ADDENDUM
NO. 1

July 16, 2020

Additions & Renovations to Lawrence North High School
7802 Hague Road
Indianapolis, IN 46256

PREPARED BY SCHMIDT ASSOCIATES FOR:
LAWRENCE NORTH HIGH SCHOOL RENOVATION
LAWRENCE TOWNSHIP, M.S.D. OF

LL. **Drawing Number MH1H1**

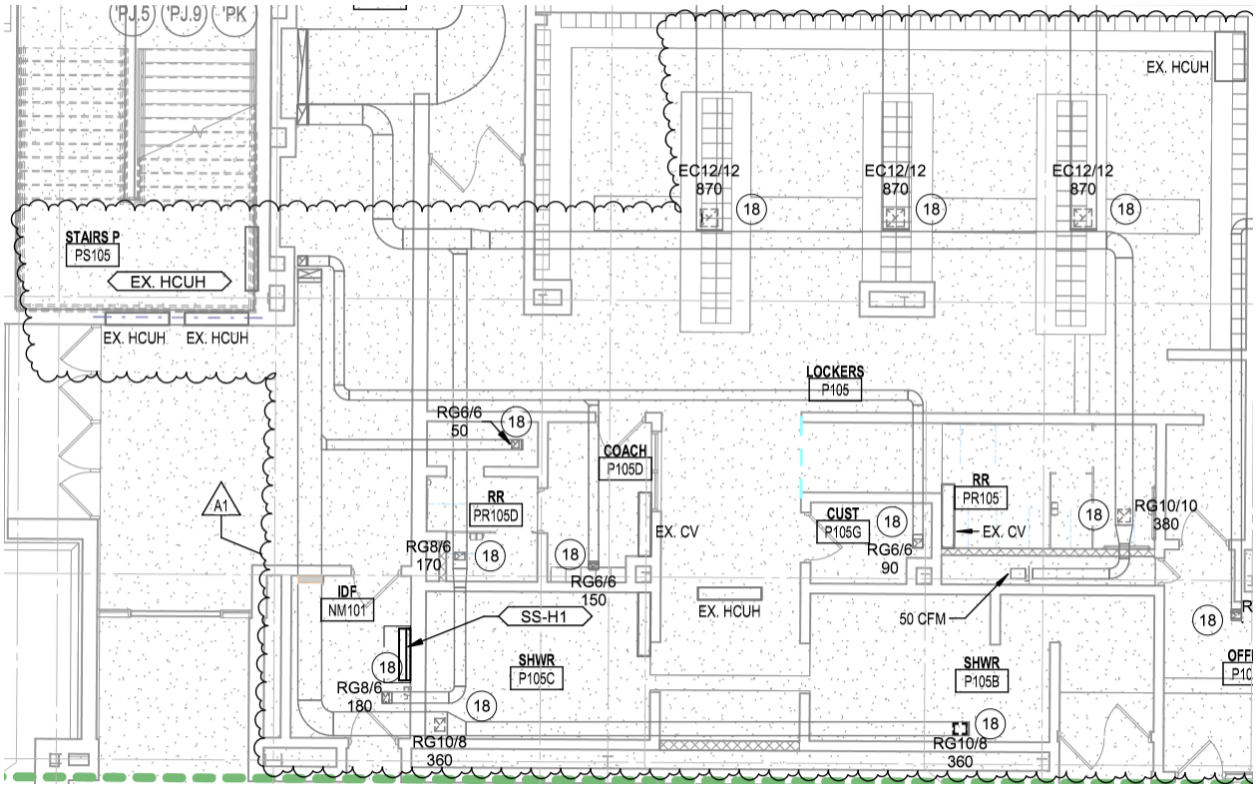
1. MODIFY drawing to show existing ductwork to be reconnected to new diffusers & grilles as follows:

MM. **Drawing Number MH1J1**

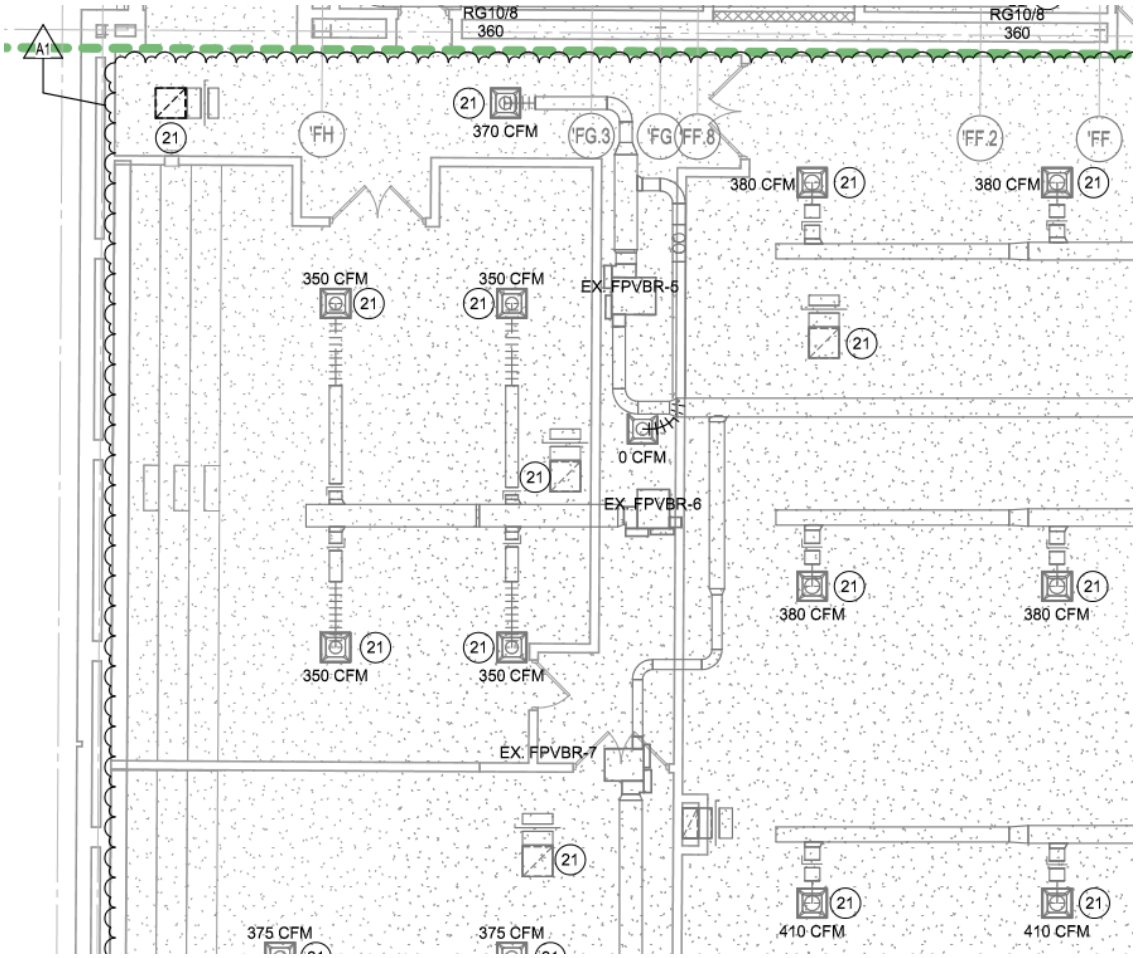
1. MODIFY drawing to show existing diffusers & grilles to be cleaned and reinstalled in new ceiling grid as follows:

NN. **Drawing Number MH1J1**

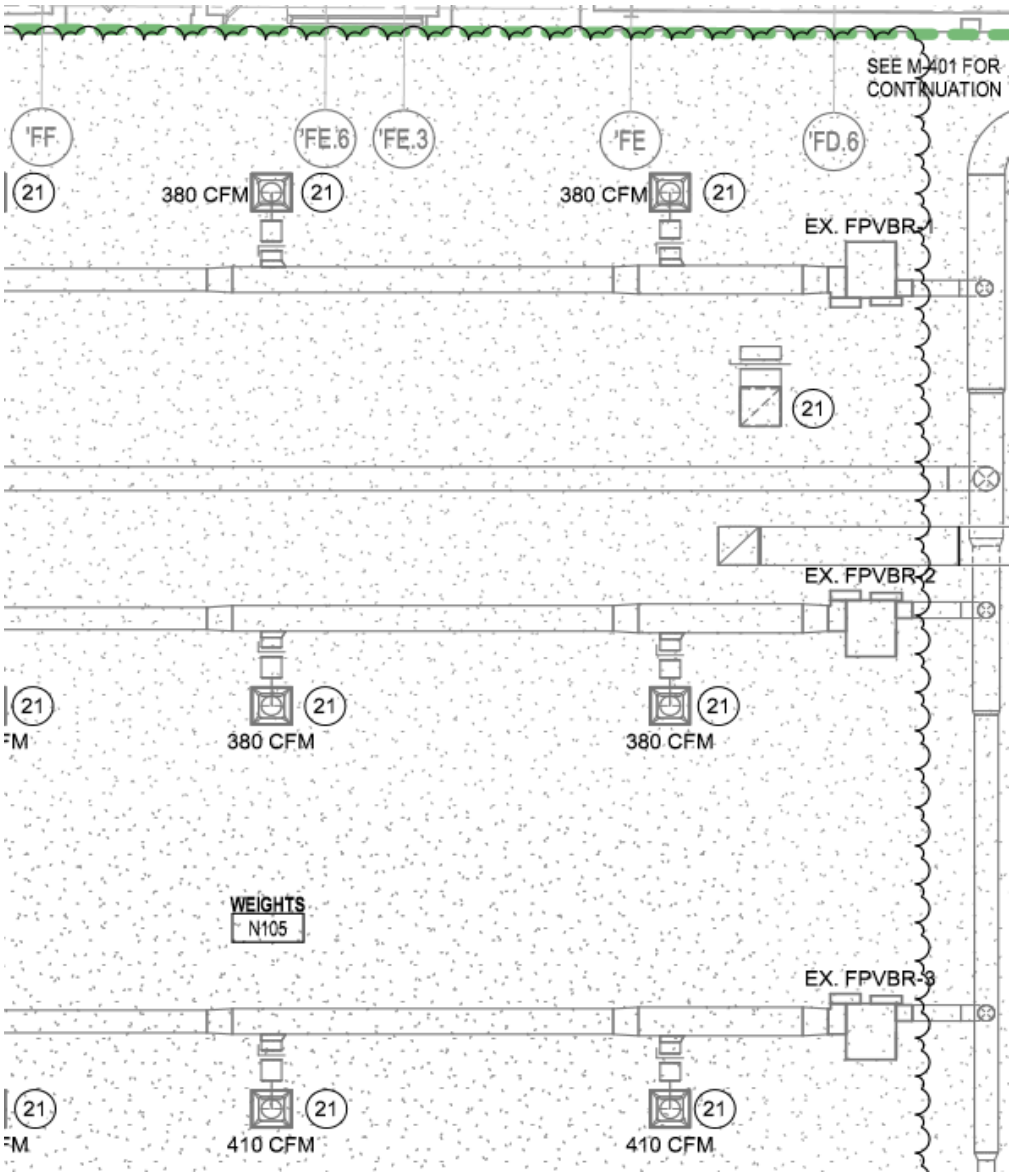
1. MODIFY drawing to show existing diffusers & grilles to be cleaned and reinstalled in new ceiling grid as follows:

OO. **Drawing Number MH1J1**

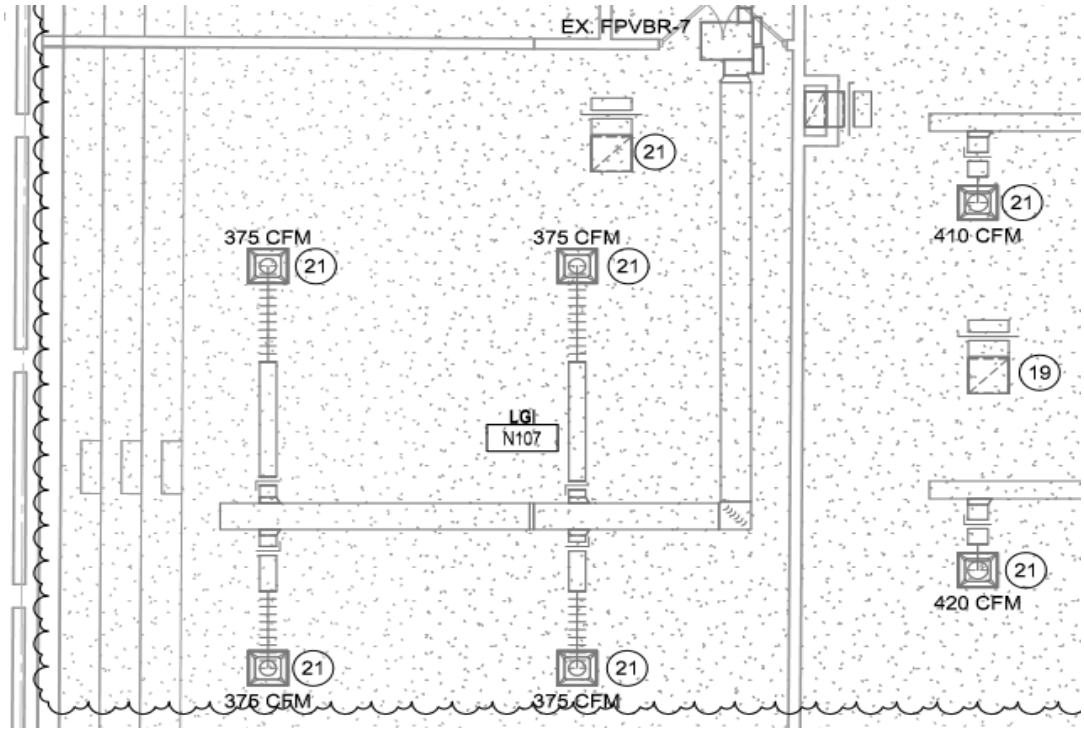
1. MODIFY drawing to show existing diffusers & grilles to be cleaned and reinstalled in new ceiling grid as follows:

PP. **Drawing Number MH1J1**

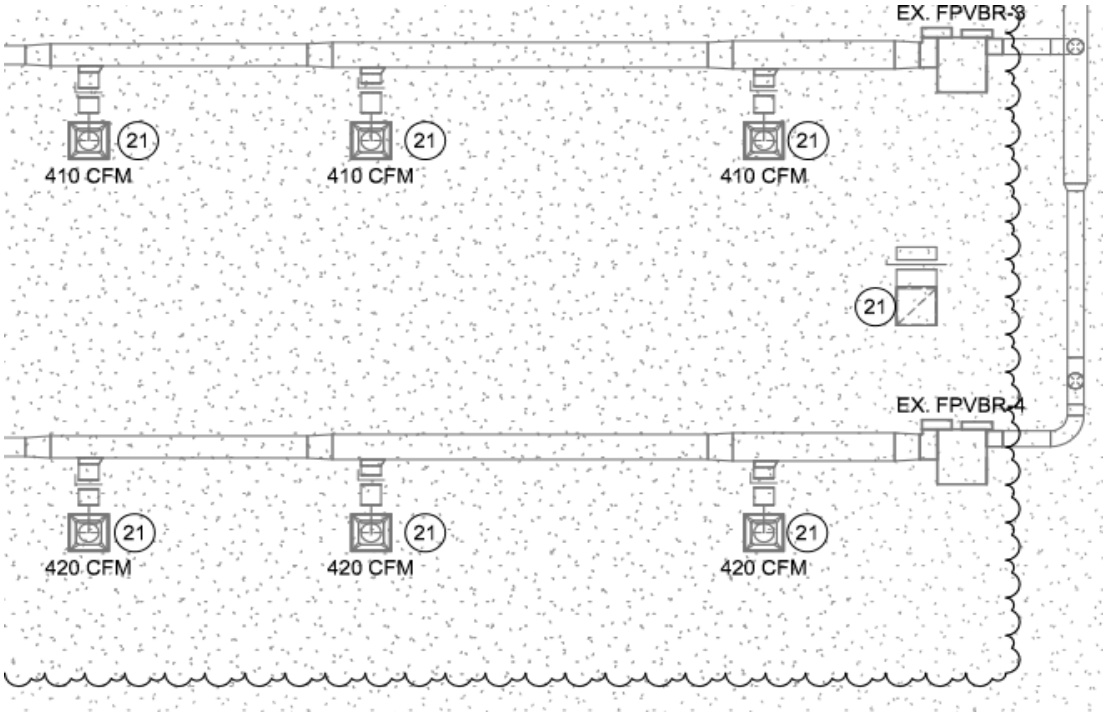
1. MODIFY drawing to show existing diffusers & grilles to be cleaned and reinstalled in new ceiling grid as follows:

QQ. **Drawing Number MH1J1**

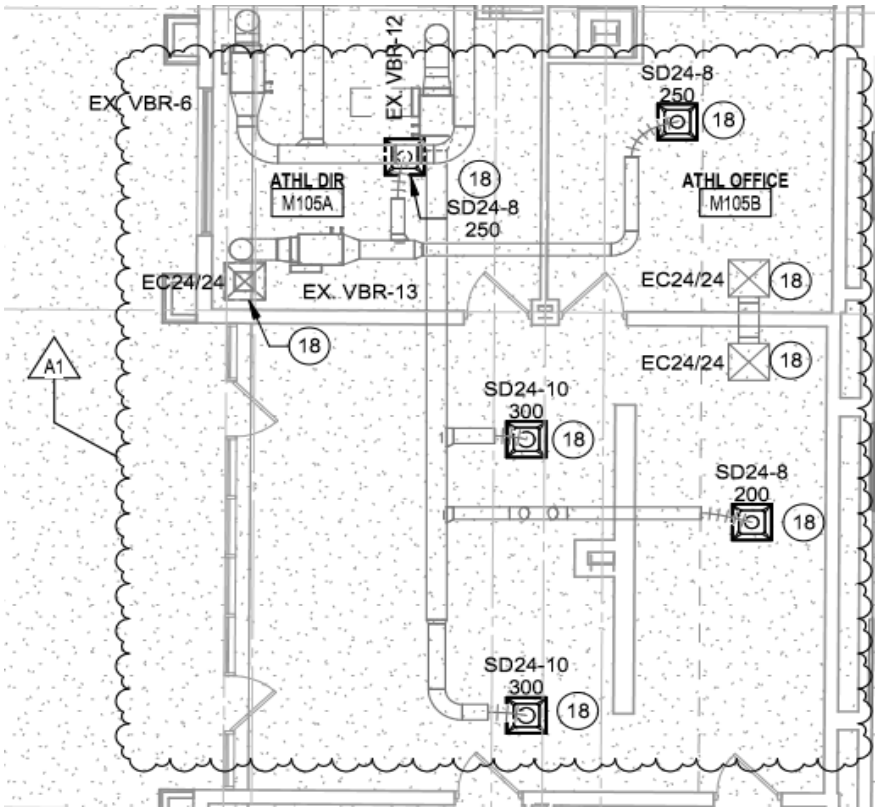
1. MODIFY drawing to show existing ductwork to be reconnected to new diffusers as follows:

RR. **Drawing Number MH1J1**

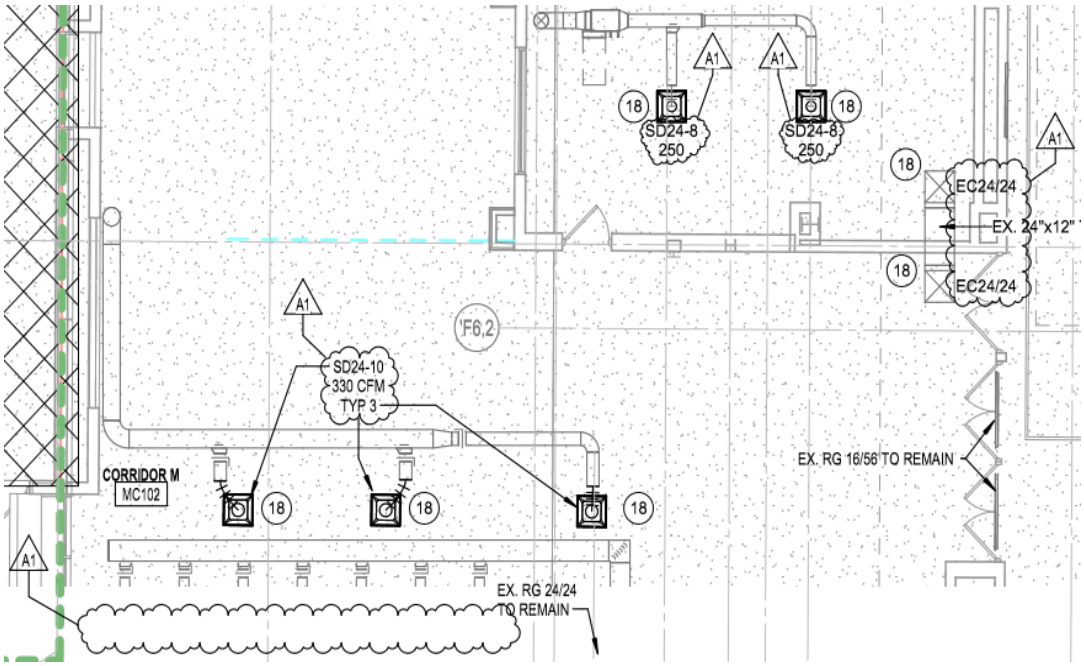
1. MODIFY drawing to show existing ductwork to be reconnected to new diffusers as follows:

SS. **Drawing Number MH1J1**

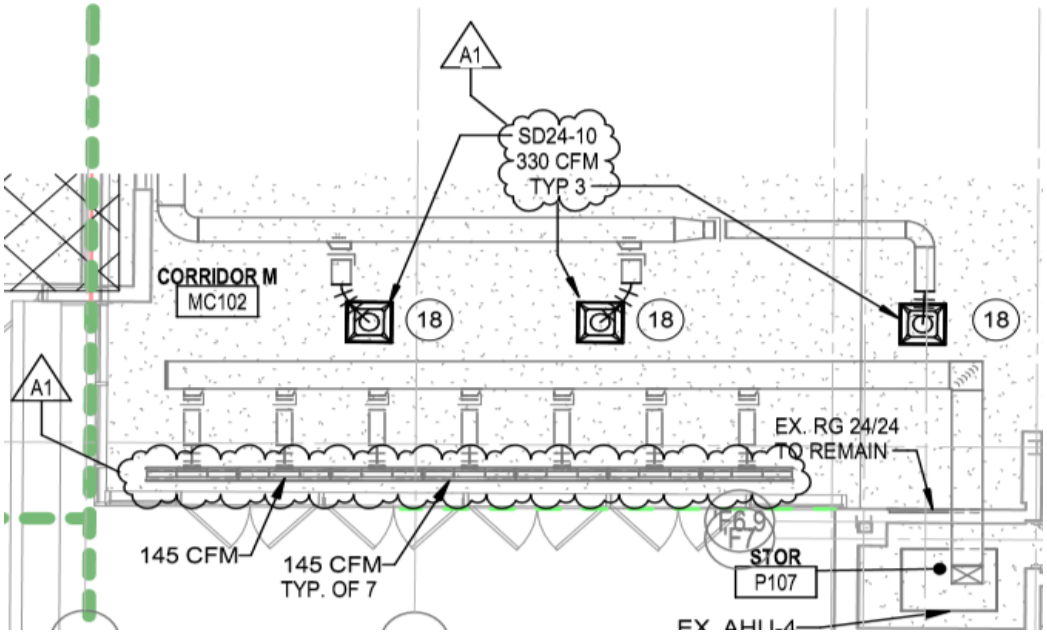
1. MODIFY drawing to show existing ductwork to be reconnected to new diffusers and CFM adjustments as follows:

YY. **Drawing Number MP1D1**

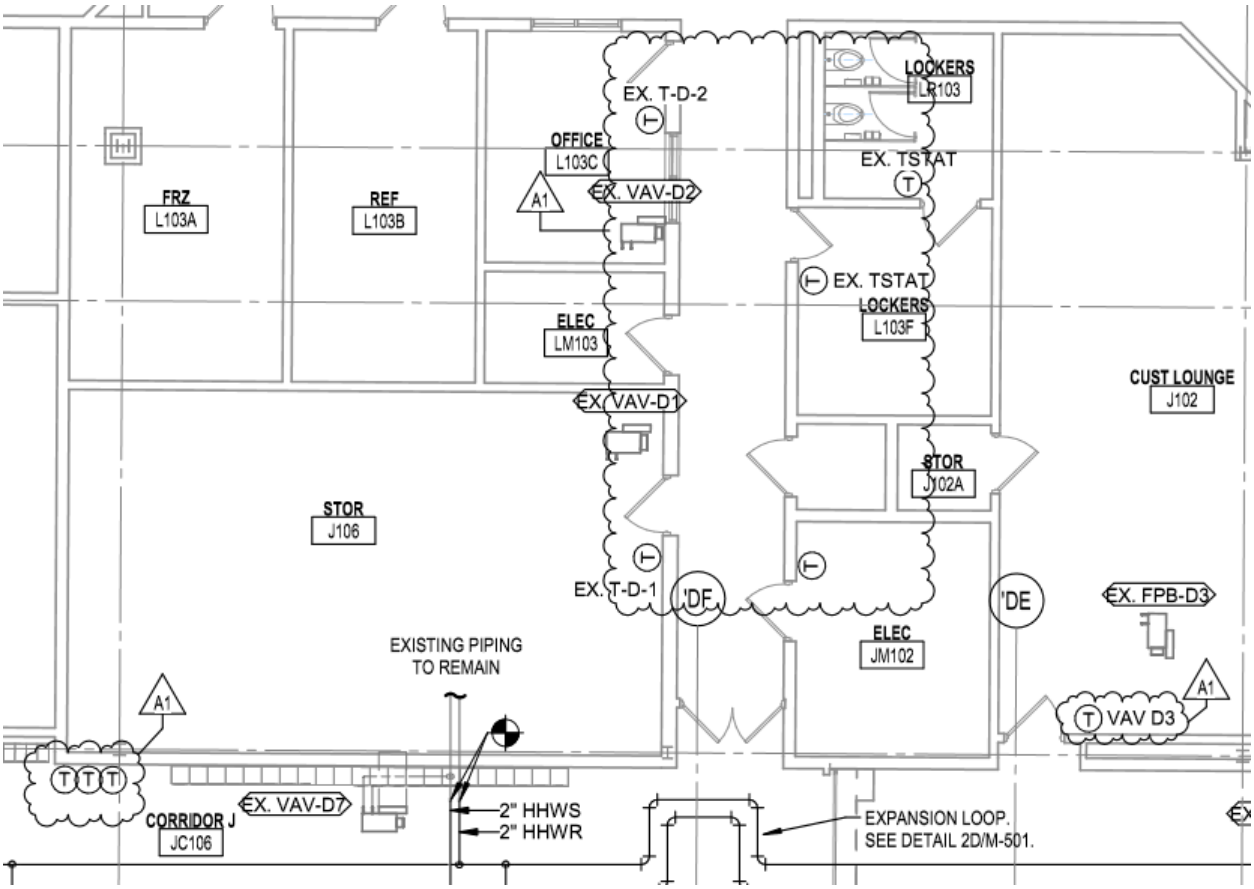
1. MODIFY drawing to show location of new thermostats as follows:

AAA. **Drawing Number MP1D1**

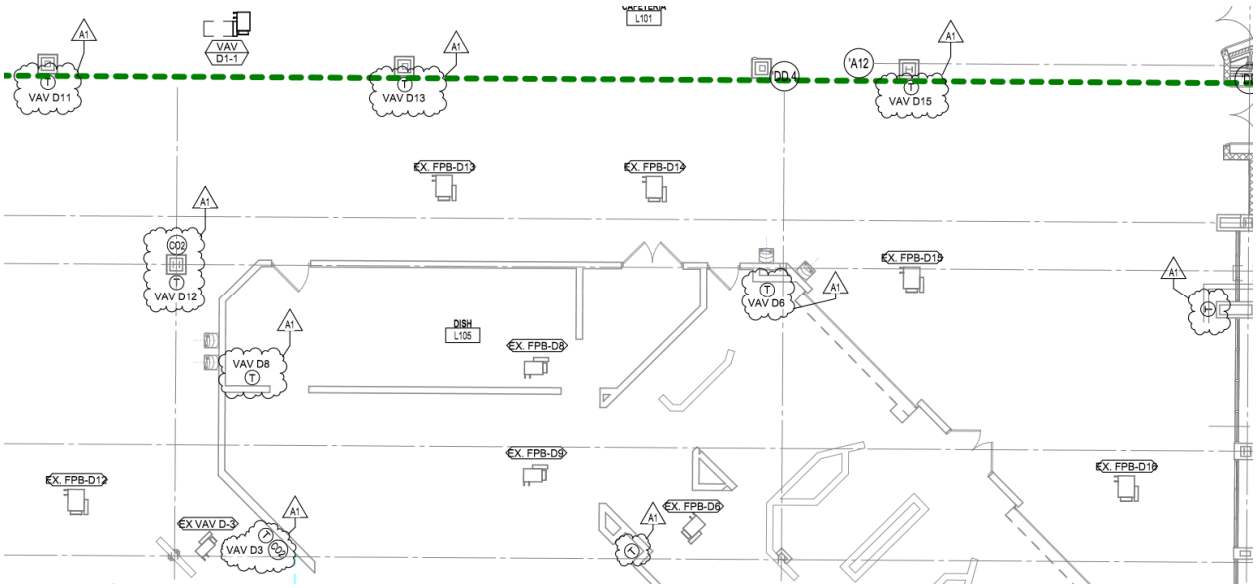
1. MODIFY drawing to show location of new thermostats & CO2 sensor as follows:

BBB. **Drawing Number MP1D1**

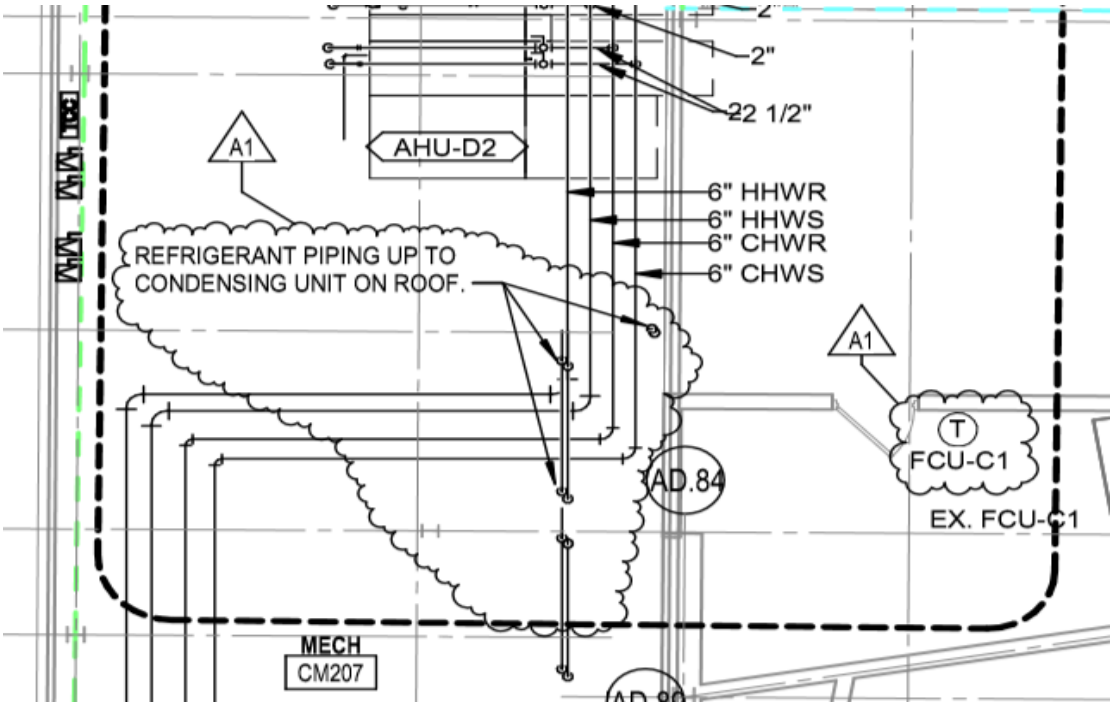
1. MODIFY drawing to show location of new thermostats & routing of refrigerant piping as follows:

DDD. **Drawing Number MP1E1**

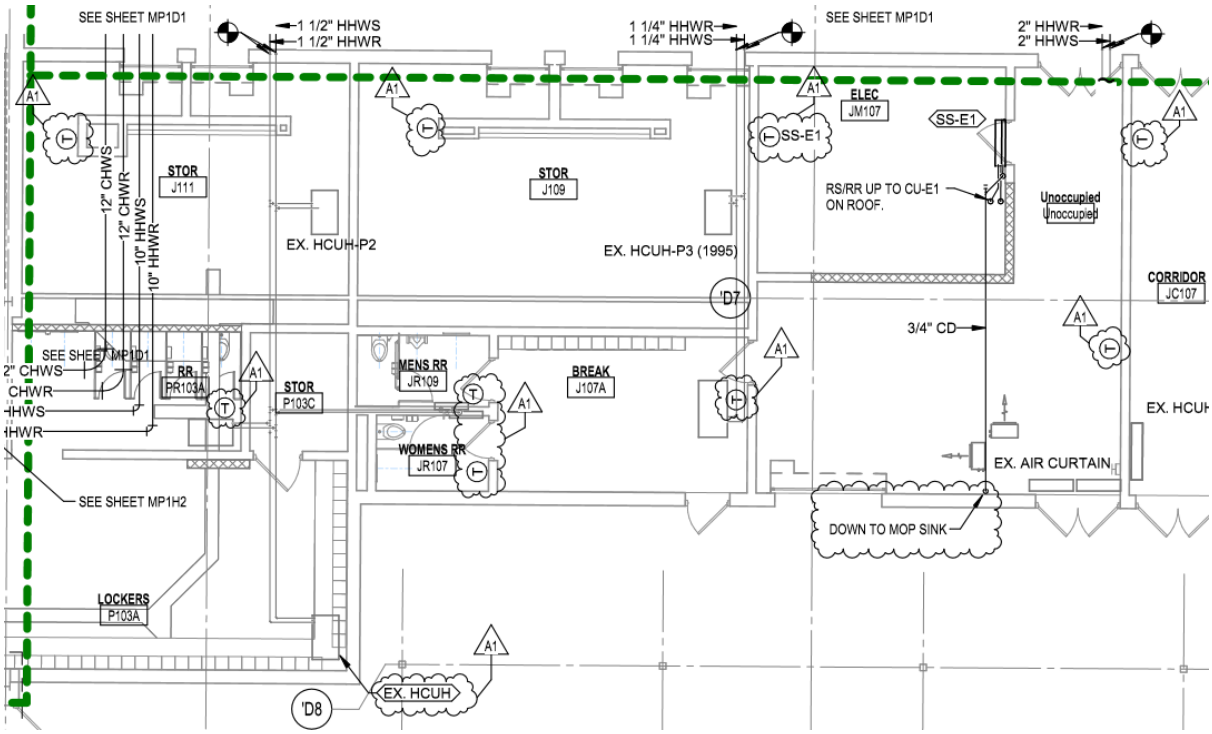
1. MODIFY drawing to show location of new thermostats as follows:
